RE: **Lot 13 Block 10, Volcano Cliffs, Unit 22, SAD 228
6300 Petirrojo NW
Grading and Drainage Plan
Engineers Stamp Date 2/10/20 (D10D003F13A)**

Based upon the information provided in your submittal received 2/10/20, this plan is approved for Grading Permit.

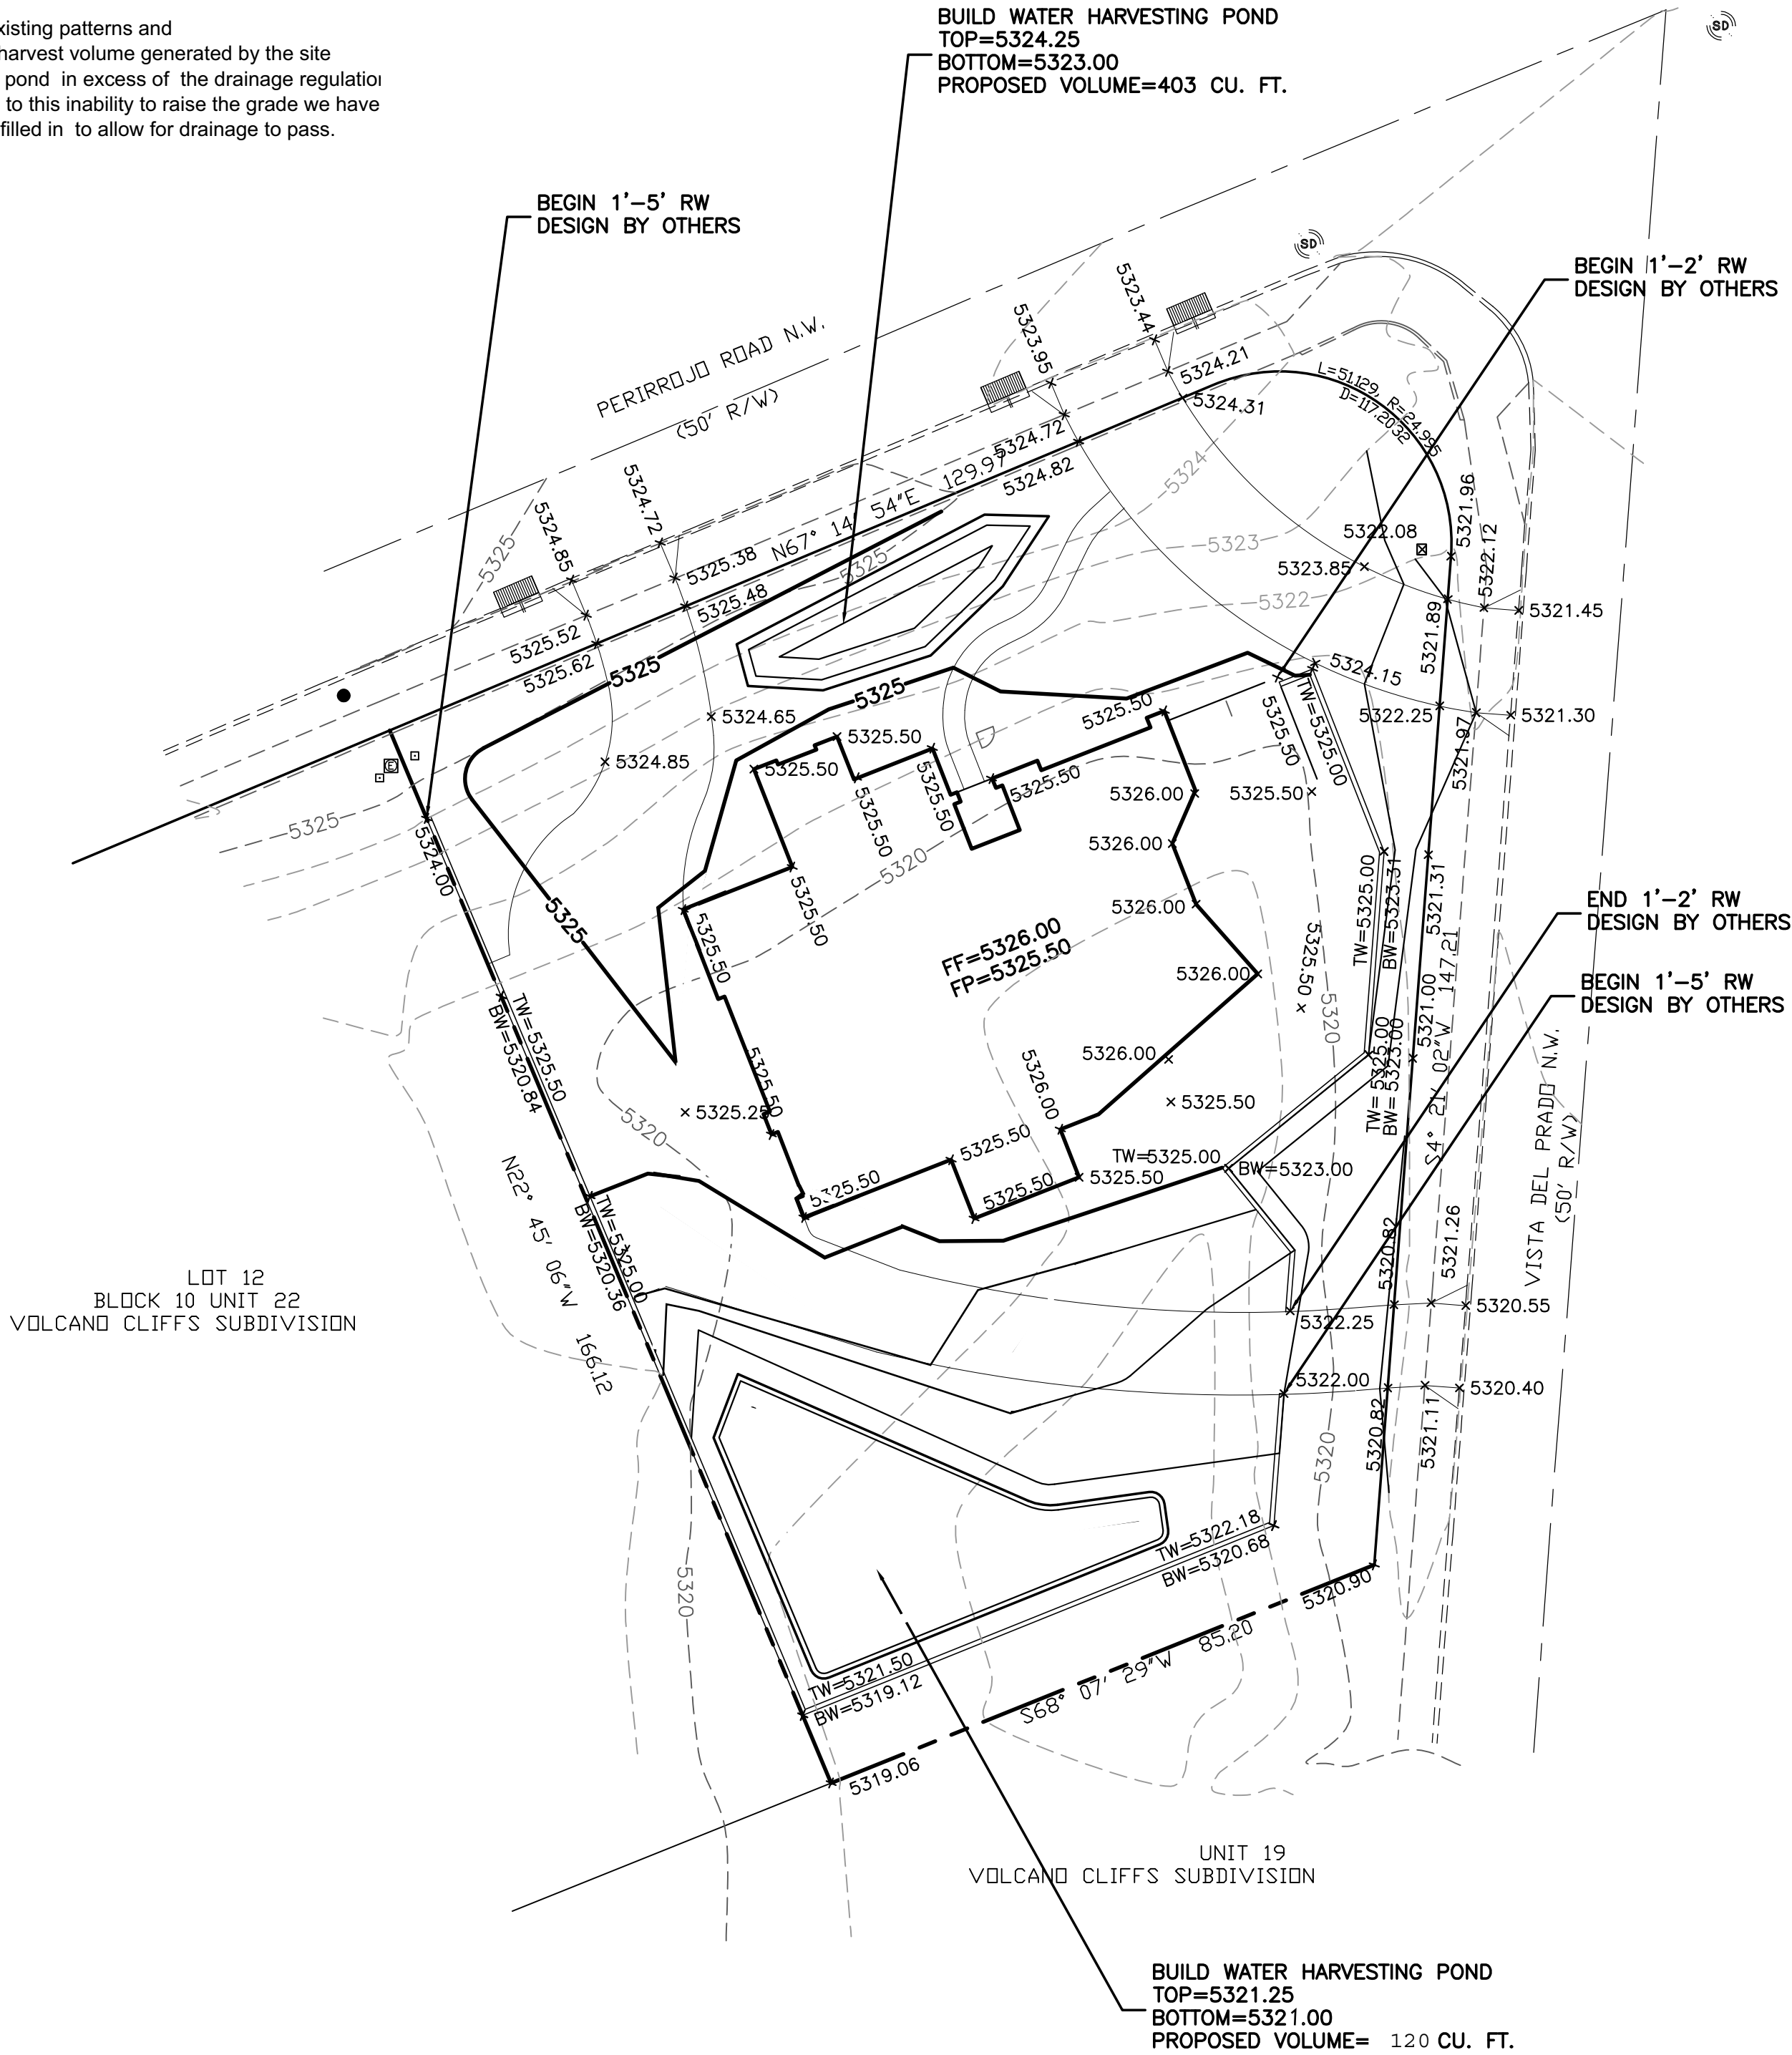
Prior to Building permit approval a Pad Certification will be required, provided by the Engineer or a registered Land Surveyor.

Advise the owner contractor not to use dirt as a ramp to climb the curb, use lumber or crusher fines for this purpose.

Reiterate to the Owner/Contractor that a separate permit for a garden/retaining wall must be obtained with the approved G&D plan and Pad Certification. Also, if a swimming pool is to be placed the grading and drainage plan will change and will need to be resubmitted.

Prior to Certificate of Occupancy release, Engineer Certification per the DPM checklist is required.
